TRANS/WP.29/2001/61
24 August 2001

PROPOSAL FOR DRAFT SUPPLEMENT 2 TO THE 01 SERIES
OF AMENDMENTS TO REGULATION No. 67

(Equipment for liquefied petroleum gas)

Transmitted by the Working Party on Pollution and Energy (GRPE)

Figure 3: connecting area of the light vehicle Euro filling unit"

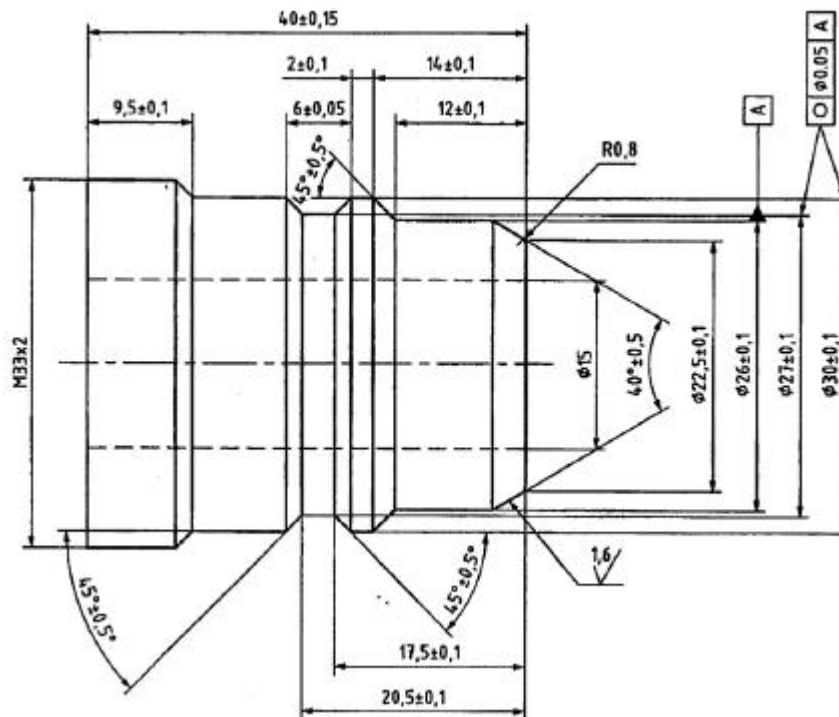
"6.15.10.6. Specific provisions regarding the light vehicle Euro filling unit (Annex 9 - Figure 3):

6.15.10.6.1. The dead volume between the front sealing surface and the front of the non-return valve shall not exceed 0.1 cm³;

6.15.10.6.2. The flow through the connector at a pressure difference of 300 kPa shall be at least 60 litres/min, if tested with water.

Insert a new Figure 3, to read:

Figure 5: Connecting area of the heavy-duty vehicle Euro filling unit"

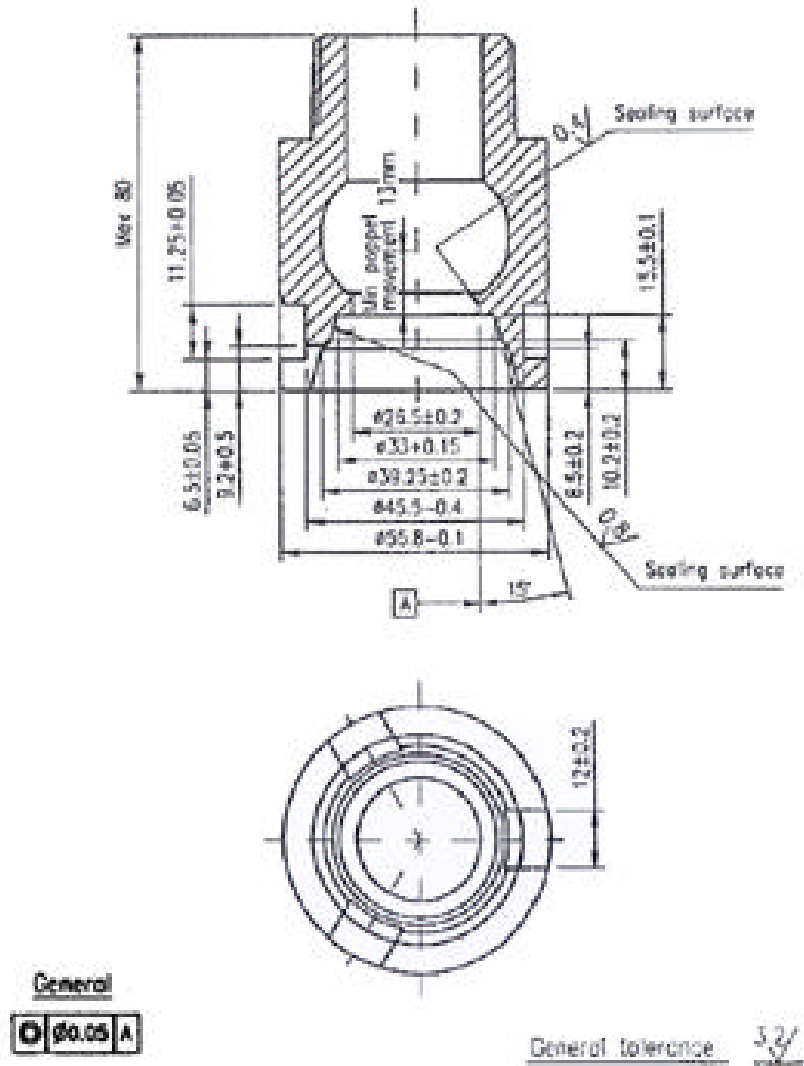
6.15.10.7. Specific provisions regarding the heavy-duty vehicle Euro filling unit (Annex 9 - Figure 5):

6.15.10.7.1. The dead volume between the front sealing surface and the front of the non-return valve shall not exceed 0.5 cm³;

6.15.10.7.2. The flow through the filling unit, with the non-return valve mechanically opened, at a pressure difference of 500 kPa shall be at least 200 litres/min, when tested with water."

Insert a new Figure 5, to read:
